Technical change to Y-distributor (1881710000 - SAI-Y-5S M12/M12 2BO)

the Y-distributor **1881710000** - SAI-Y-5S M12/M12 2BO will be changed.

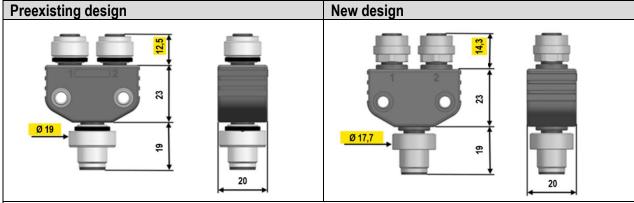
Until now, a lead-containing material was used for the threaded rings of the affected article. As part of the changeover, these will be converted to a lead-free material so that the products comply with the RoHS Directive without exception 6c. The change will result in deviations in the dimensions of the existing article. All other technical specifications remain identical.

Note: the two pins for ensuring the distance during assembly are not shown, **but remain in the new** design with the same dimensions!
